Subject: **Drawing 2-2 Update, Alton Coal Development, LLC, Coal Hollow Mine, Kane County, Utah, C/025/0005**

Permittee: Alton Coal Development, LLC
Mine: Coal Hollow Mine **Permit Number:** C/025/0005
Title: Drawing 2-2 Update

COAL HOLLOW PROJECT
ALTON, UTAH

DRAWING: 2-2

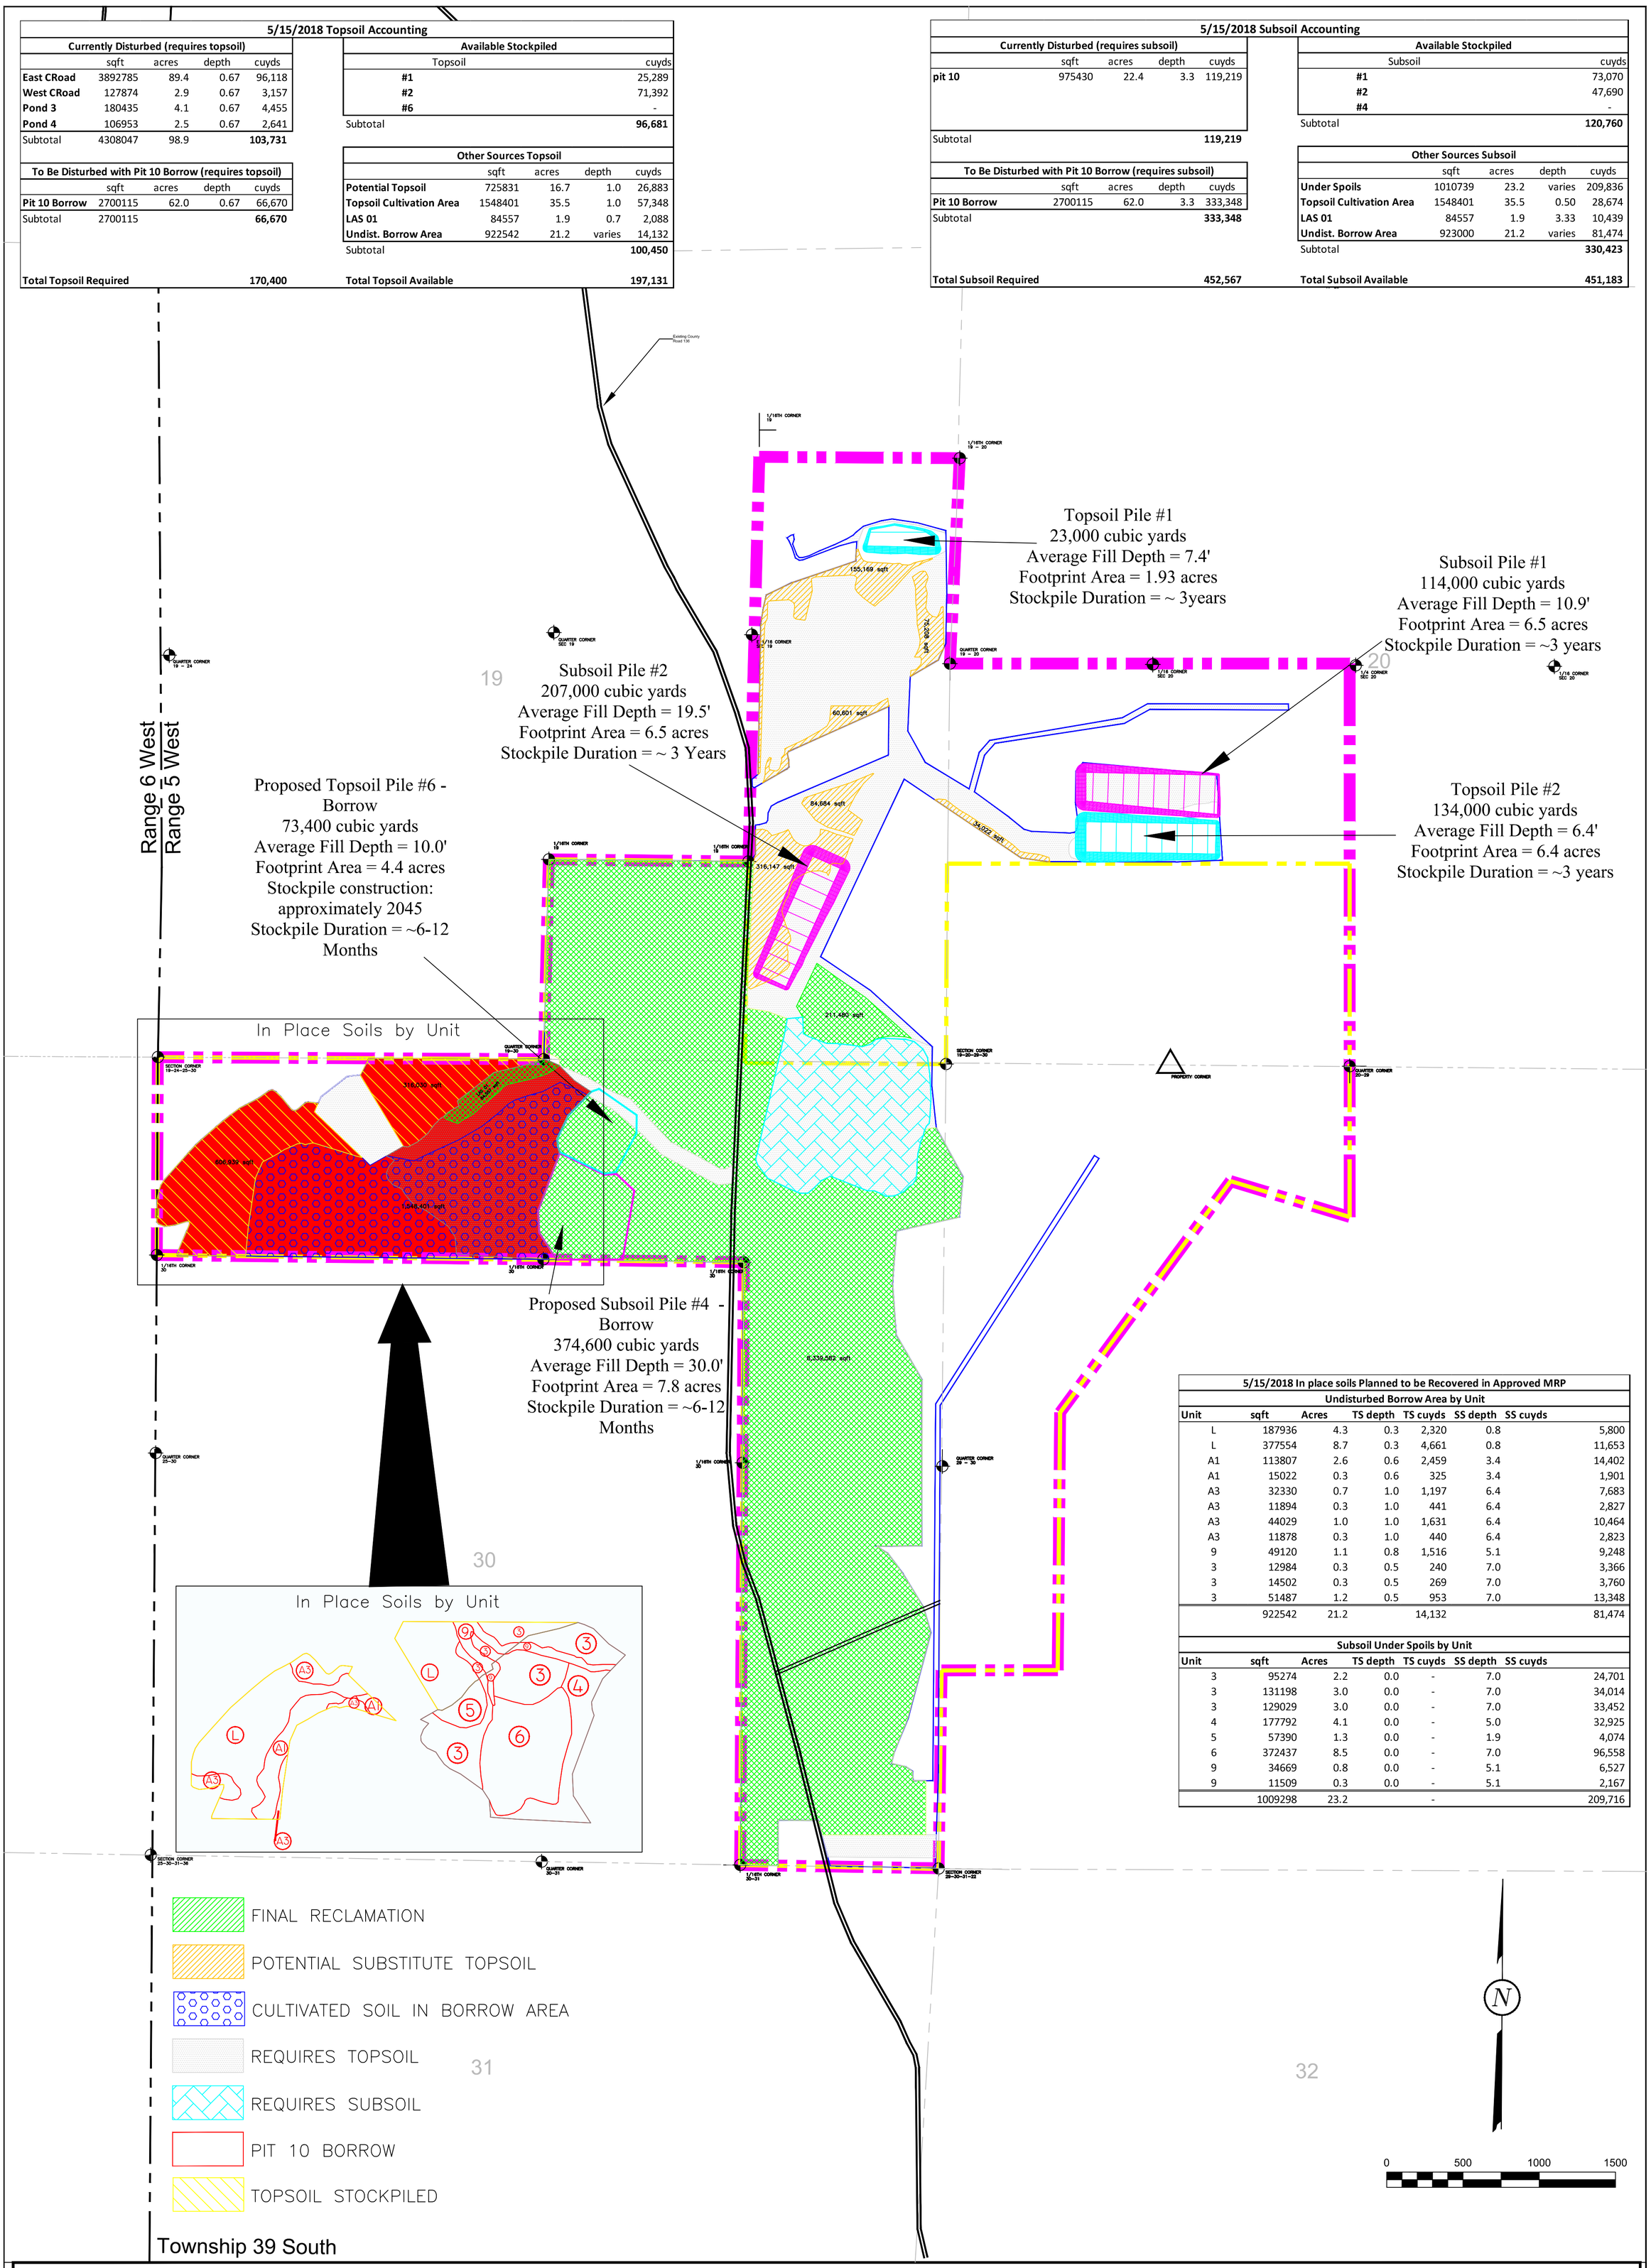
Alton Coal Development, LLC (ACD) is submitting the MRP changes in response to a Technical Inspection on July 9, 2018. As noted in inspection report 6189, sludge from Pond 1 had been placed on a 66,800 sqft area below the pond and can no longer be considered substitute topsoil. This area has been removed from the drawing. Information from Table 1 of Chapter 2 has now been updated and incorporated in Drawing 2-2.
